SUBDIVISION COMMITTEE
METROPOLITAN AREA PLANNING COMMISSION

STAFF REPORT
(Final Plat, Preliminary Plat Approved 7/29/04)

CASE NUMBER: SUB 2004-93 -- MESA VERDE ADDITION

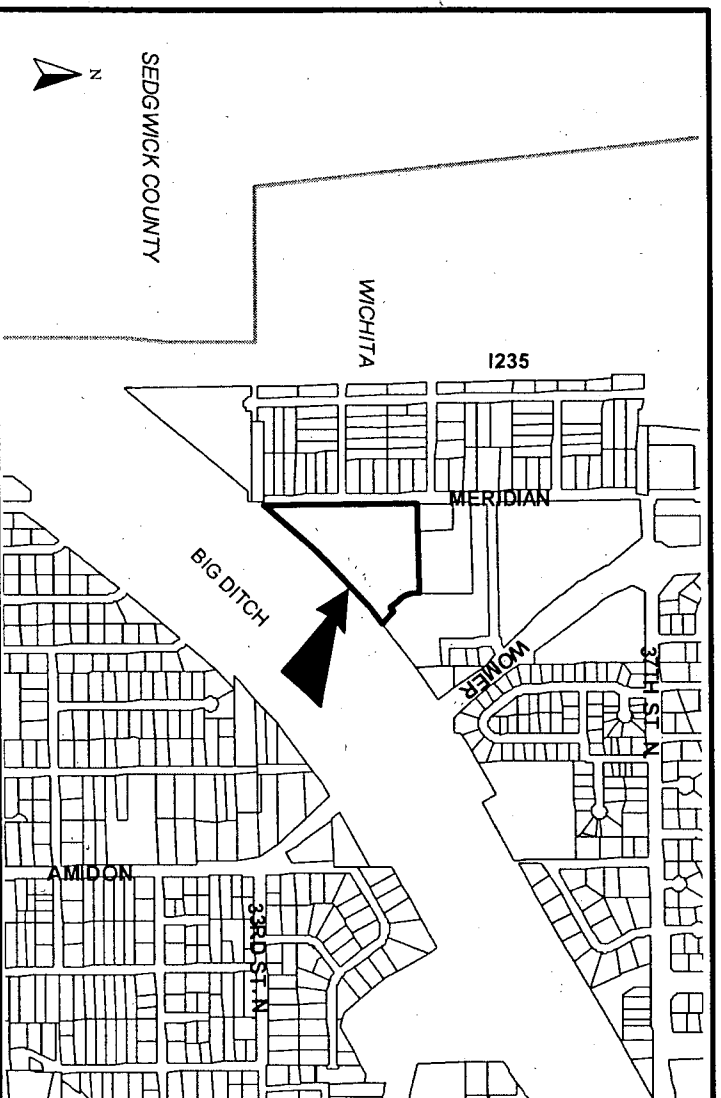
- A. The applicant shall guarantee the extension of sanitary sewer and City water to serve the lots being platted. City Engineering needs to comment on the need for other guarantees or easements.

- C. City Engineering needs to comment on the status of the applicant's drainage plan.
- D. The Applicant shall guarantee the paving of the proposed streets.

- E. Since this plat proposes the platting of narrow street right-of-way with adjacent "15-foot street drainage and utility easements", a restrictive covenant shall be submitted which calls out restrictions for lot-owner use of these easements. Retaining walls and change of grade shall be prohibited within these easements as well as fences, earth berms and mass plantings.

- F. The applicant shall submit a covenant which provides for four (4) off-street parking spaces per dwelling unit on each lot which abuts a 32-foot street. The covenant shall inventory the affected lots by lot and block number and shall state that the covenant runs with the land and is binding on future owners and assigns.

- J. Approval of this plat will require a waiver of the lot depth to width ratio of the Subdivision Regulations for Lots 5-13, Block A. The Subdivision Regulations state that the maximum depth of all residential lots shall not exceed 2.5 times the width.
